**City of Lino Lakes
Environmental Board Meeting**

**May 25, 2016
6:30 p.m.**

REQUEST: Preliminary Plat, PUD Site Plan Review Woods Edge

Preliminary Plat, Site, Grading, Utilities, Streets, and Landscape Plans

Preliminary Landscape Plan

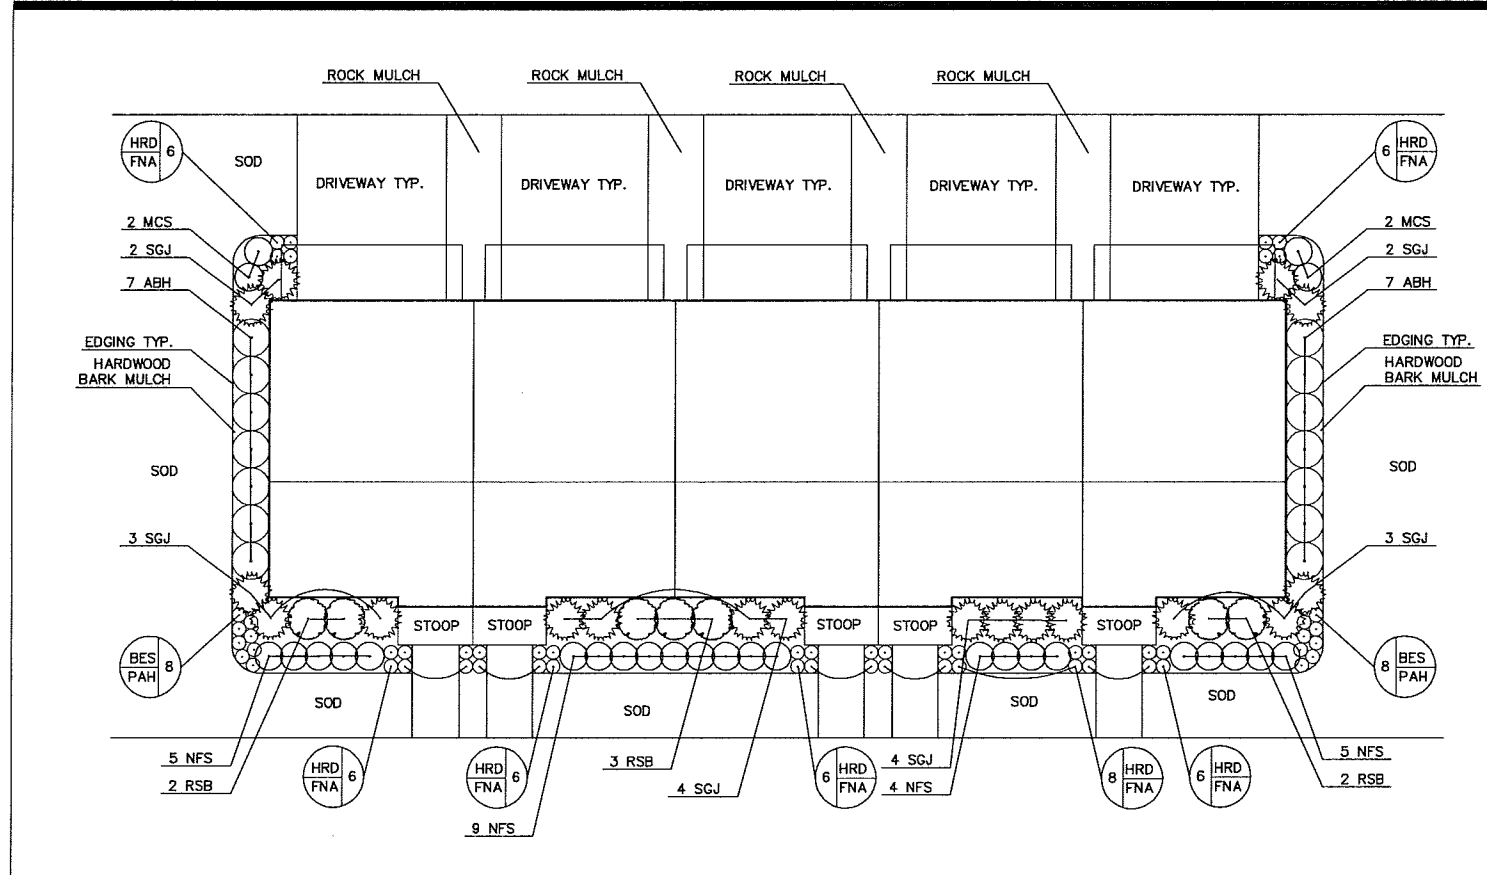
The proposed species list is attached. Going down the list looking at the landscape site plan, the following comments and recommendations are made:

1. A more detailed location plan for species and location will be needed.
2. Street trees planted on the inside private road areas and areas along village drive to east and Woods Edge Boulevard appear to have limited space for larger shade trees with large crowns.

5. White Spire Birch, on their list should not be used. It would be a very short lived tree in this location and is a very high maintenance tree.
6. "Sienna Glen" is a "Autumn Blaze Maple and is also has a high maintenance characteristic. It has a spread of 30 feet and would outgrow the planting site in Woods Edge.

10. Boulevard Linden is OK with a spread of 30'.
11. Swamp White Oak has too large of a crown and should not be used here.
12. "Princeton" Elm has too wide of a crown. If there is a corner area some place of the site, where we can have more crown width, it could be used. We do have it planted on the boulevard in this area.

15. The Ornamental Trees are OK
16. Ponderosa and Scotch pine should not be used. The only area that has conifers designed into is by the pond. It might be nice to plant Tamarack since the site is adjacent to a Tamarack bog area.

17. The shrub list is ok.
18. The following list are more upright trees that should be used for tight areas (almost the whole site):
 - a. Armstrong Red Maple should be added to the list and used as a shade tree in the tighter areas. This tree has only has about a 15 to 25 foot diameter crown. This tree is planted in front of the YMCA.

- g. "Sun Valley" Red Maple has a 10-15 foot crown spread.
 - h. "Autumn Gold Ginkgo has a crown Spread of 30 foot.
 - i. "Dakota Pinnacle" White Birch
19. Existing trees along Town Center parkway are going to have to be moved and replaced. There are sanitary sewer lines that are designed that go right through the planted tree areas. We could possibly move the trees into a stock-pile area somewhere in close proximity. There should be a water source at any stock pile site. These trees could also just be planted somewhere else and new trees planted.
